TOWN OF WILLISTON
DEVELOPMENT REVIEW BOARD
June 8, 2021, 7:00 PM
Zoom Meeting ID: 823-369-798 | 7900 Williston Road

DP 09-01.22 Snyder FC Commercial Properties LLC and Rieley Properties LLC request a discretionary permit to construct a multi-tenant commercial building (approx. 26,000 SF) on Lot C-2 (3.08 acres) in Finney Crossing at the corner of Holland Lane and Williston Road in the Taft Corners Zoning District (TCZD).

WILLISTON DEVELOPMENT REVIEW BOARD STAFF REPORT

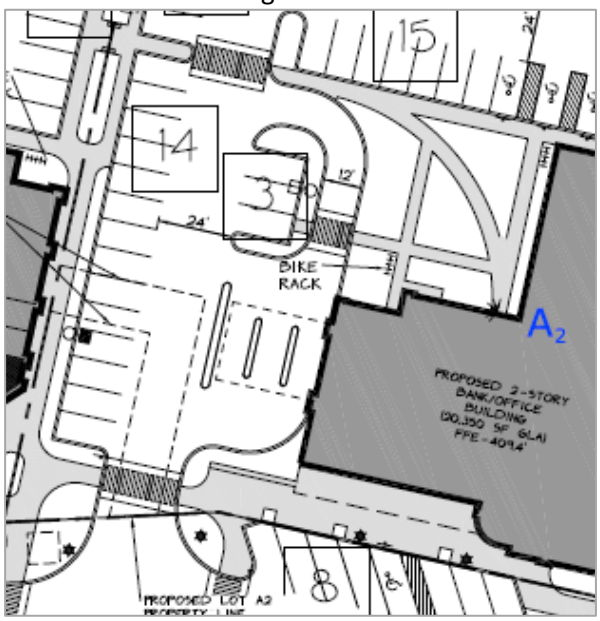
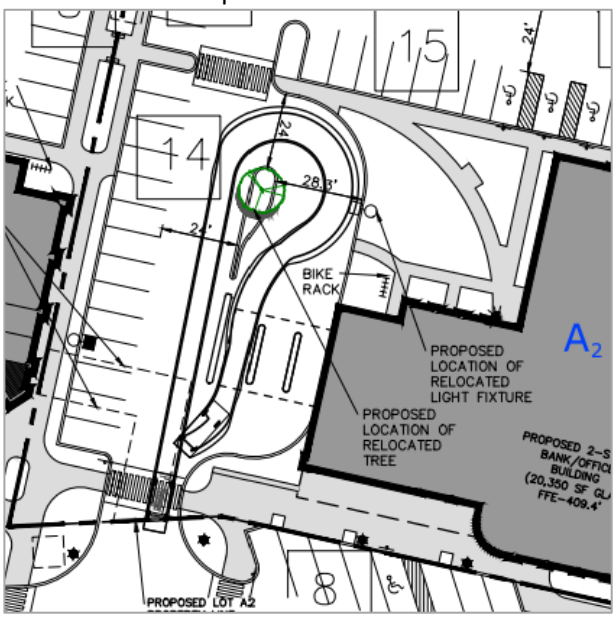
Complies as proposed. No changes to road access. One pedestrian crosswalk is being removed. However, this crosswalk only serves the 3 parking spaces which will be eliminated. Two other crosswalks remain unchanged.

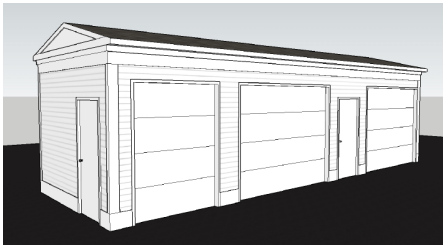
At pre-app, the DRB requested, "*solid waste containers shall be screened by placing them in the structure they serve, accessible via loading doors, or to use walls that are an architectural extension of the structure served by the containers*." While the building has been moved away from the prominent street corner, it is still a separate structure. **The DRB should discuss the location, style, and materials of the proposed solid waste building. The DRB may choose to add a condition.**

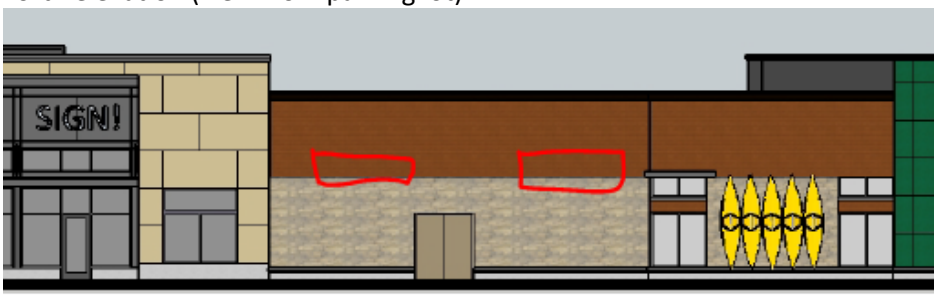
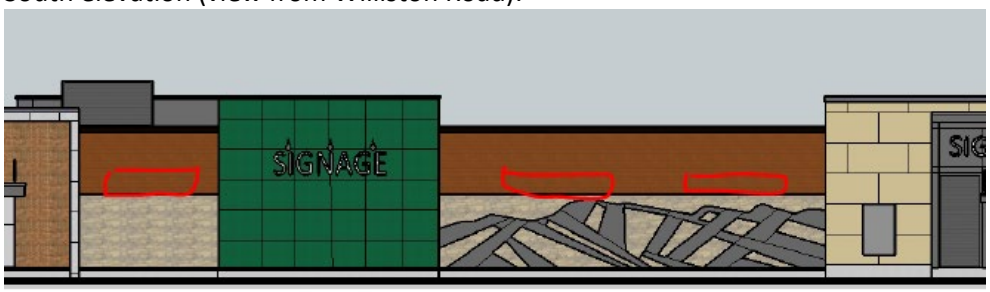
The DRB should review the HAAC recommendations and decide if additional conditions are required. The HAAC recommended additional windows on the most unadorned walls of the structure to ensure they are not defined as "dead walls" under WDB 41 and 22. At the June 1st HAAC meeting, the applicant represented that additional windows would need to be very high on the wall in order to accommodate interior retail shelving. The HAAC disliked windows that are too high up because they have an "industrial" feel, for example, the windows above the Healthy Living loading dock.

a. Add a non-vertical element (angle/sloped roof) to break up the flat roof.
    ~~b. Consider smaller, elevated windows (similar to size/style windows on east end of Building J). The windows should be approximately halfway up the wall or embedded in the stone portion rather than near the top to bring a "human scale" to the wall and avoid an "industrial" feel as shown.~~
    c. Consider an angled awning ~~support by wooden columns~~ to bring more dimension and a porch roof effect. ~~See LL Bean sample photos as selected by HAAC.~~
    d. Landscaping and lighting comply as proposed for the pathway between Building E and Union Bank.
    e. Consider a cornice or molding that compliments Union Bank. Consider other materials. (~~Complies as proposed in June 3rd renderings~~). **Continue the cornice and red elements on the north elevation.**

2. PARTIAL EAST ELEVATION: 1/8" = 1'-0"

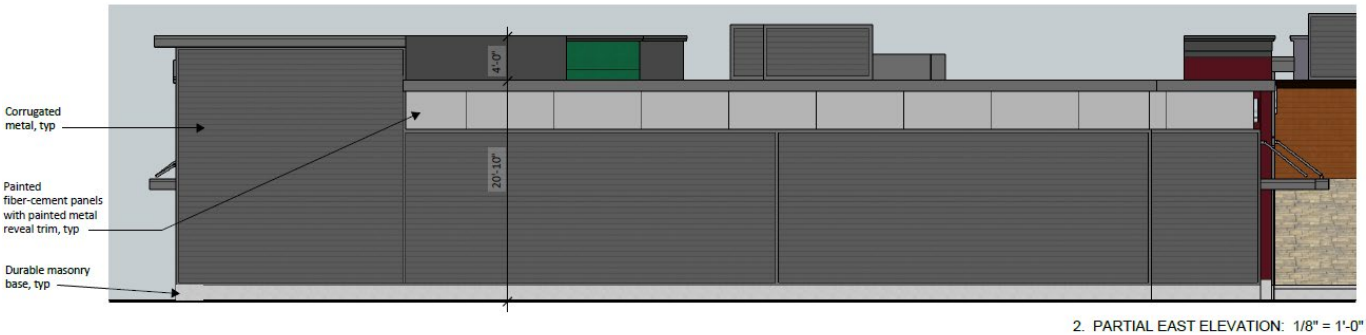
Cleary B stated maybe there could be a trellis or some sort of plant species that would climb up the building. Chris S discussed the challenges with the landscaping in that area as the plants might struggle. Pete K stated that this wall is not an issue that will hold up approval and they can delegate the review to staff. John H agreed and stated that the landscape architect could try to work something out for that wall facing Union Bank.

Lastly, the DRB should consider the pedestrian experience along the pathway between Building E and Union Bank. The HAAC did not write recommendation about the east façade:

22. Provide a change of color, texture, material or building applied landscaping on the lower 4 to 8 feet of the east façade facing Union Bank.
